FILE NO.: 1-E-20-HZ

PROPERTY LOCATION: 2301 Jefferson Ave. /

LEVEL OF WORK: Level III. Construction of new primary building

STAFF FINDINGS:

2301 Jefferson Ave. Front Elevation

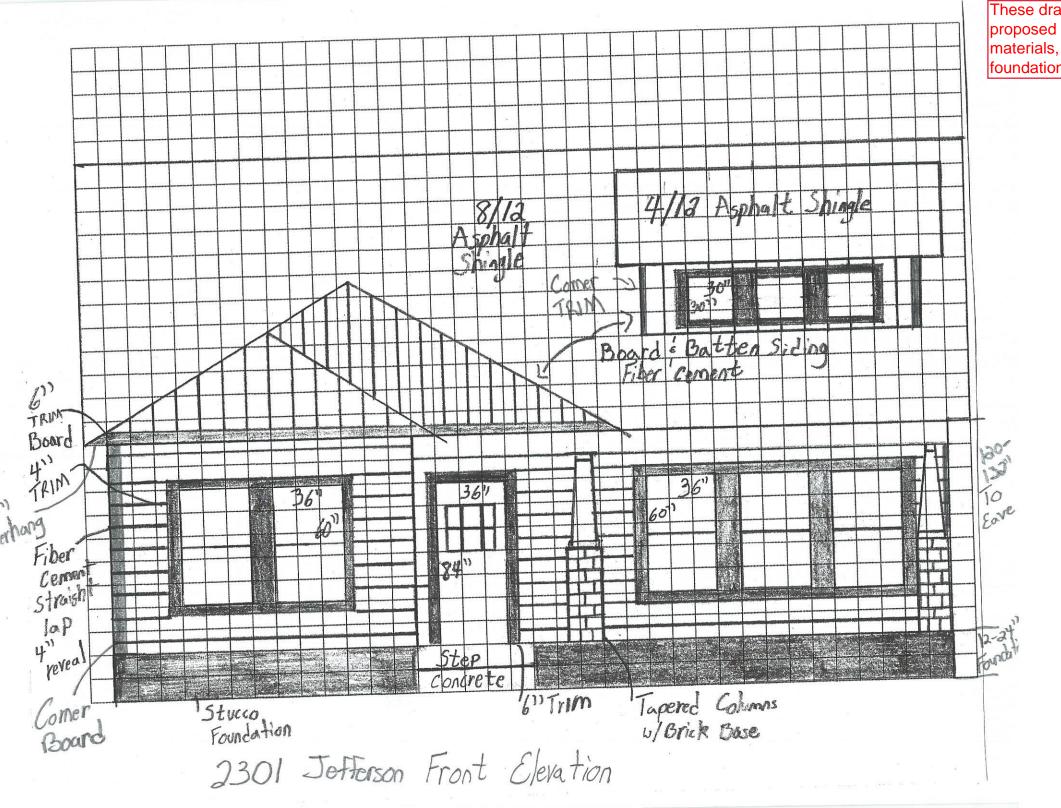
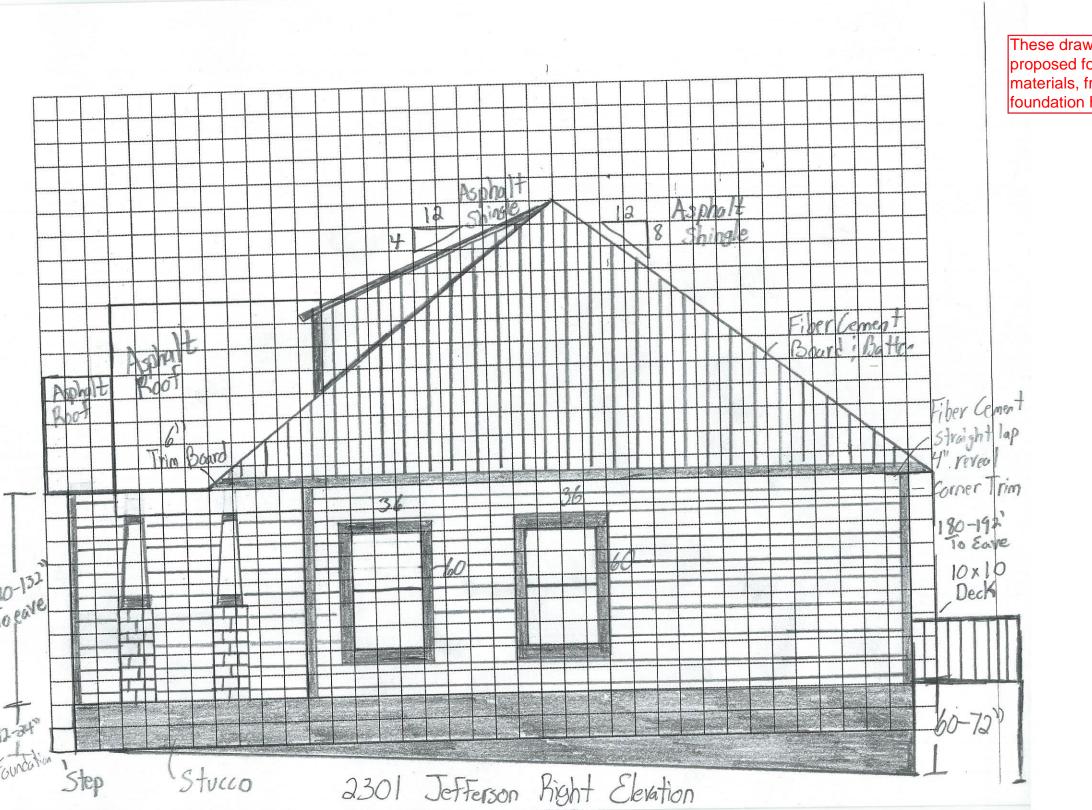
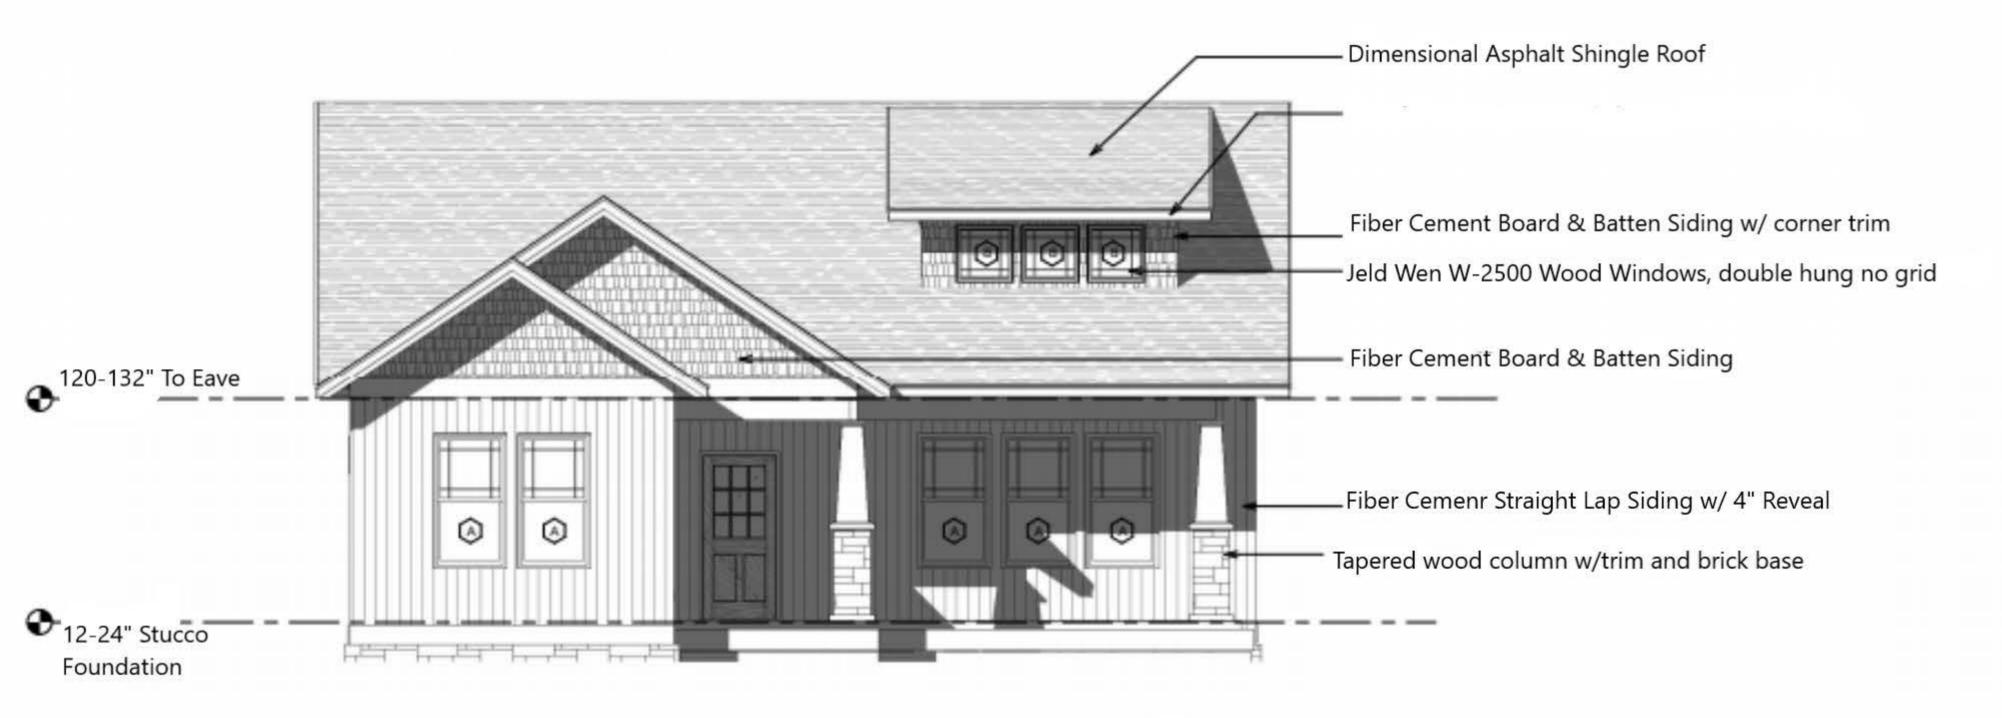
- 1. The proposed residence features side yard setbacks appropriate for a corner lot and reflects the side setbacks of the adjoining corner-lot house at 2119 Jefferson Avenue. The rear setback of 84' is also appropriate. The proposed front setback is 16' from the front property line. The 2300 block of Jefferson Avenue features nine houses and one church, with an average setback from front property lines at 10.2 feet. The adjacent house at 2307 Jefferson Avenue, at 16', is somewhat set back from the remainder of the block. Across Olive Street, 2117 and 2119 Jefferson Avenue reflect setbacks of 11'. A front setback between 11'-14' from the property line would better fit the neighborhood context.

- 2. The 1½ story design is respectful of the surrounding context, which features a mix of 1½ story Craftsman houses, one-story Queen Anne cottages, and several two-story houses. The house's rectangular massing with a recessed corner porch is an appropriate overall form. A bay or other massing on the side elevations (or at minimum, the side elevation fronting Olive Street) would help create a "mix of wall areas" like those found on nearby historic houses; additional complexity on the side elevation is necessary to avoid a "boxlike form."

- 3. The side-gable roof form with a shed-roof dormer is appropriate for a Craftsman-style house. The 8/12 pitch proposed for the primary roof massing is sufficiently steep for a Craftsman-style house in the neighborhood context. Eave overhangs of at least eight inches are necessary to reflect historic eave patterns.

- 4. The proposed design features a raised foundation which reflects the topography of the lot. The foundation's change in height from the front to the rear of the house is reflected in the adjacent house at 2119 Jefferson Avenue. The applicant has stated the roof height is 21'-1" plus the foundation. The foundation is described as 24' from the ground on the façade elevation and 72' from the ground at the rear elevation; therefore, the house would be 23'-1" tall at the façade elevation.

- 5. The recessed porch is 23'-5" long and 6' deep. While Edgewood-Park City guidelines do not have a specific number for porch depth, comparable historic districts recommend 8' minimum depth for porches. A poured concrete floor and concrete steps are appropriate for new construction on the block, as several houses on the neighboring blocks of Jefferson Avenue feature concrete porch floors. The beadboard ceiling and tapered wood piers on brick columns are consistent in appearance with historic materials.

Staff recommends approval of the work as proposed with the following conditions: 1) window and door trim to be 4" wide, and corner boards and horizontal trim under gable fields to be 6" wide; 2) the porch be revised to be 8' deep, with new design approved by staff; 3) roof eaves must have an overhang of at least 8"; 4) additional architectural elements (such as a bay window, small projecting bay, or chimney) be added to the side elevation fronting Olive Street; and 5) the house's setback from the front property line be reduced to between 11' and 14' to better reflect the streetscape.
